**BAKER CENTER (CITY FILE #DR/PAR 20-02)**  
**TABLE OF CONTENTS**  
**(PLANNING COMMISSION MEETING 8-10-20)**

## Staff Report File #: DR 20-02 / PAR 20-02 – Baker Center

**1 LIGHTING PLAN**  
G2.0  
1" = 50'-0"  
0 50 100 150

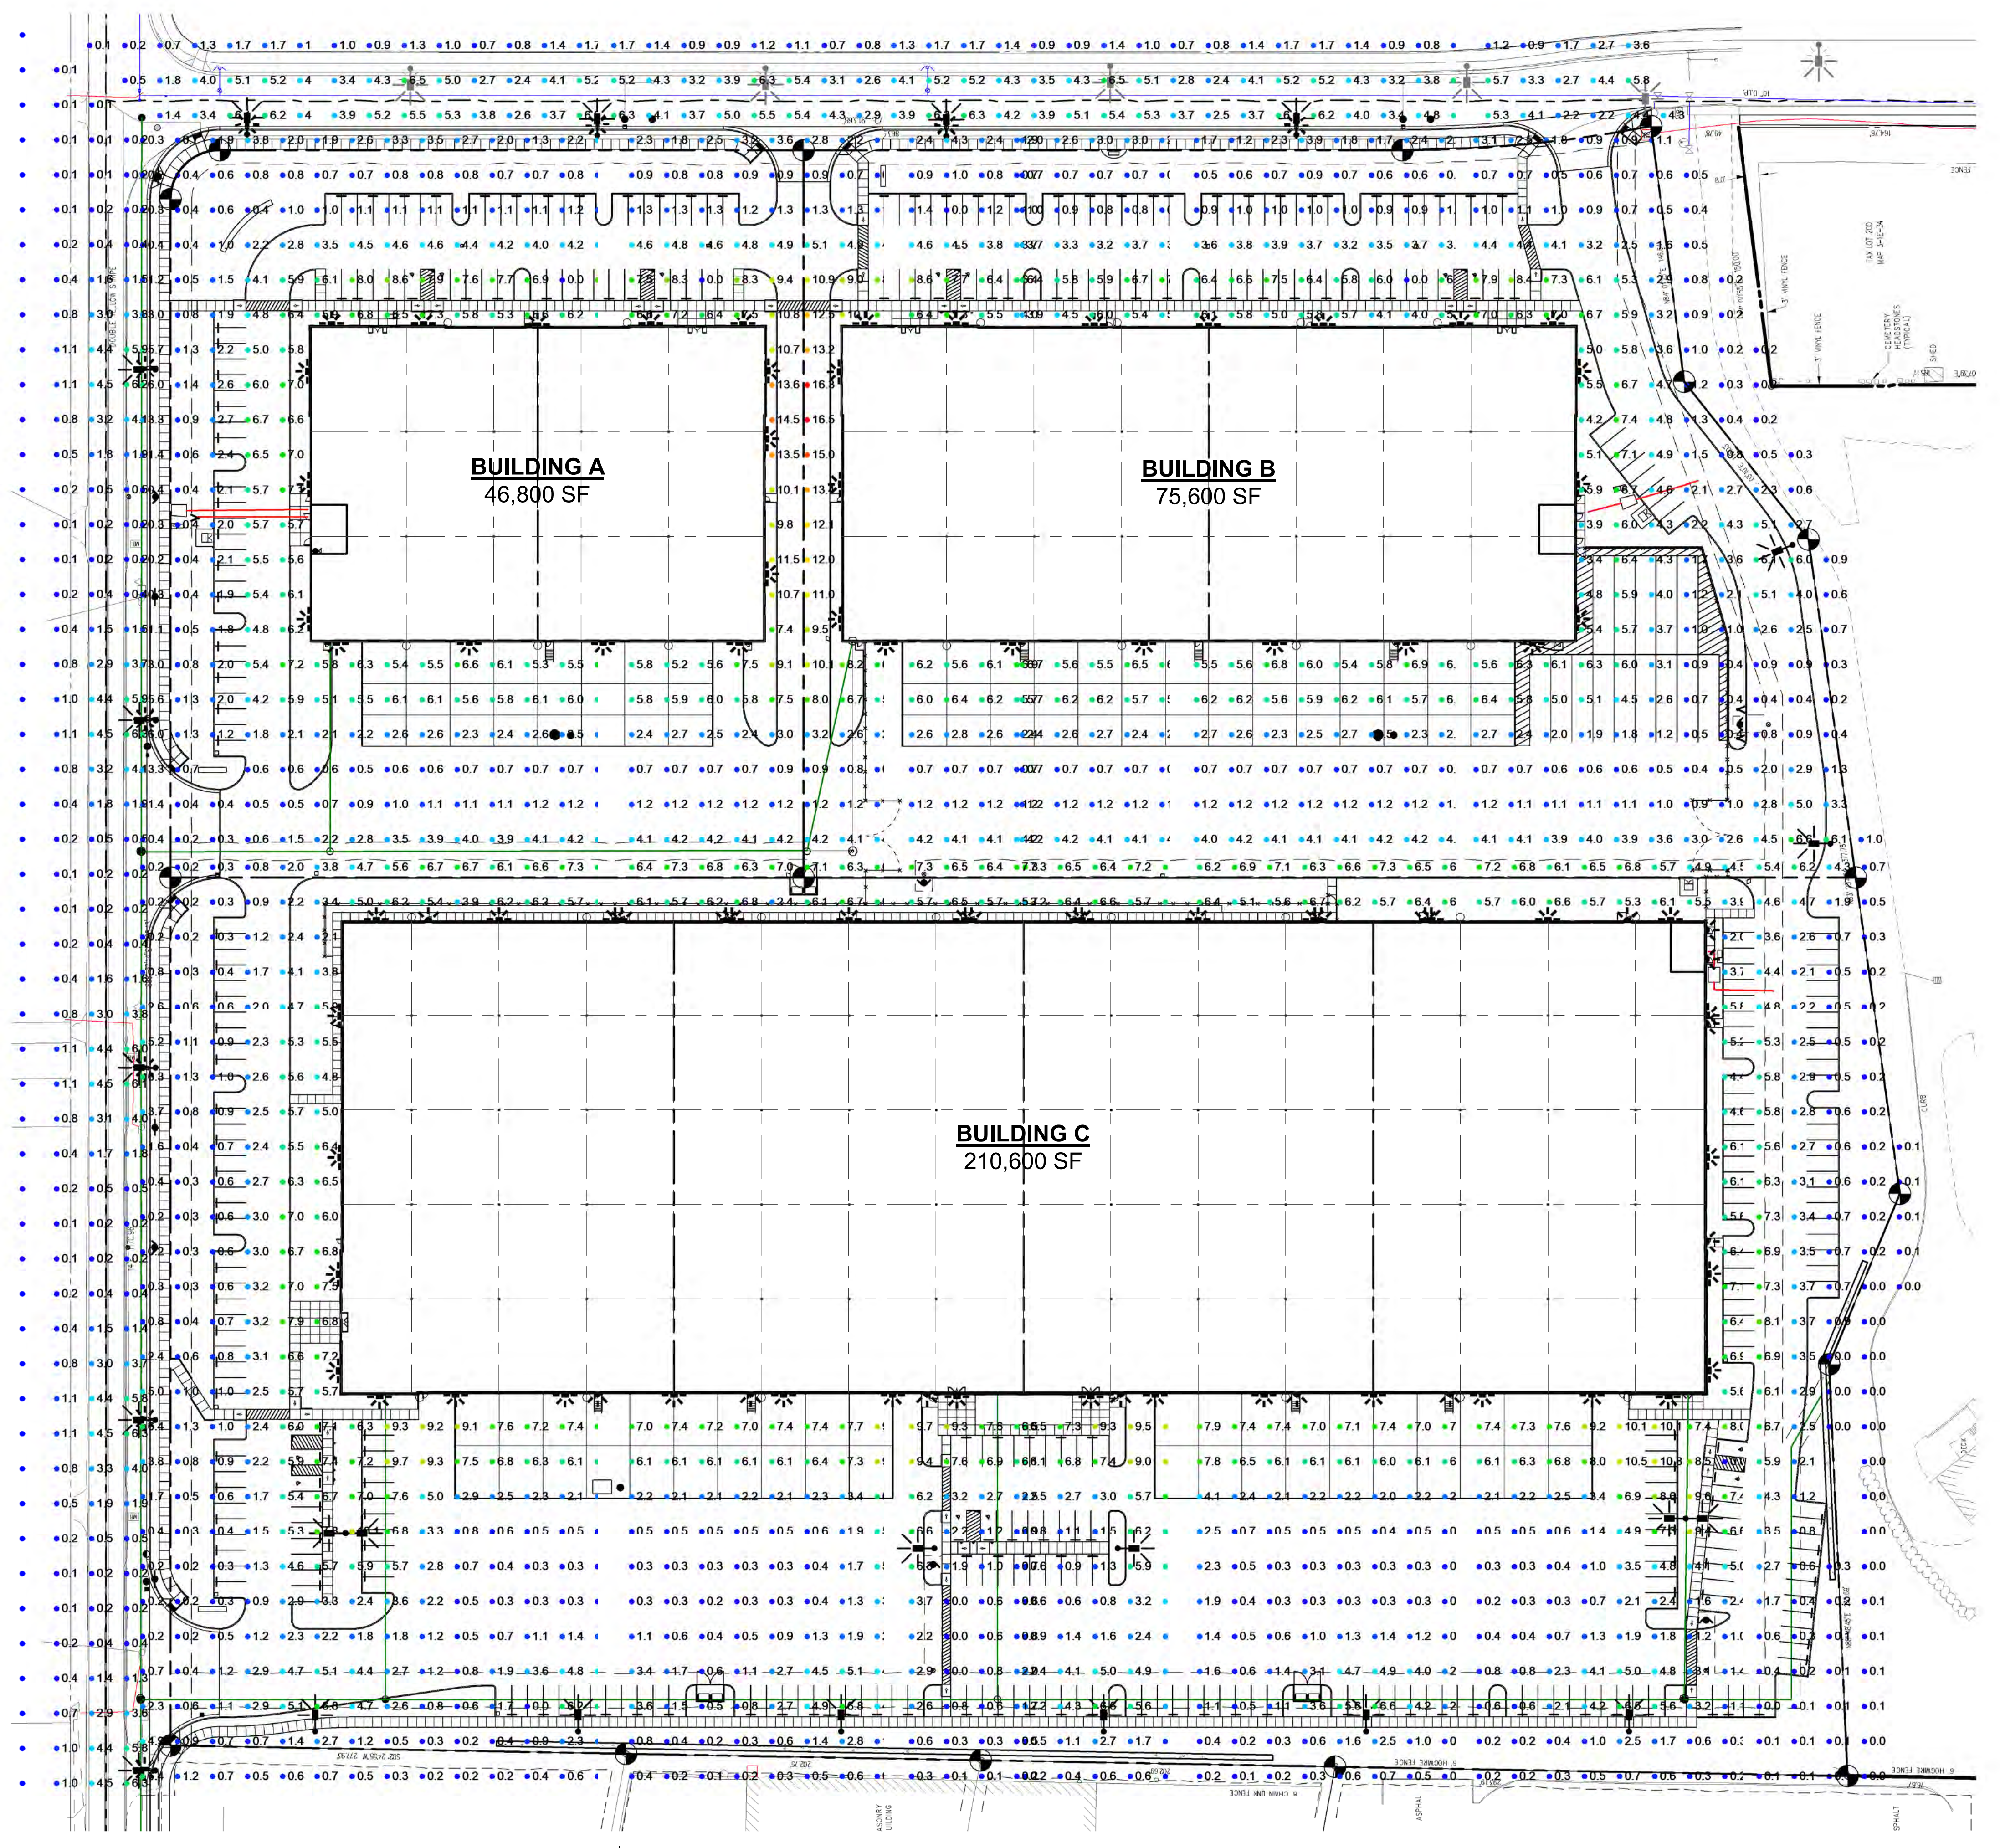
As currently proposed, Staff does not anticipate a lack of compliance with City lighting standards. The provided photometric plan demonstrates that light overspill onto surrounding properties is minimal (between 0 and 1 foot candles). Furthermore,

landscaping has been designed to minimize glare from headlights onto the site from surrounding streets and vice-versa. However, prior to site plan approval, the project applicant will be required to submit a lighting plan to the City of Canby consistent with Section 16.43.110 of the Municipal Code. Section V of this Staff Report includes a condition of approval requiring that a more comprehensive lighting plan to be submitted showing how the proposed light fixtures and luminaires meet the requirements (e.g., shielding) of this section.

33. Prior to site plan approval, a lighting plan shall be submitted to the City consistent with Chapter 16.43, *Outdoor Lighting Standards*, of the Municipal Code. This shall include an exhibit(s) demonstrating that the proposed light fixtures would be shielded and that light generated would not exceed the maximum lumens identified in Table 16.43.070 of the Canby Municipal Code. (R. Potter)
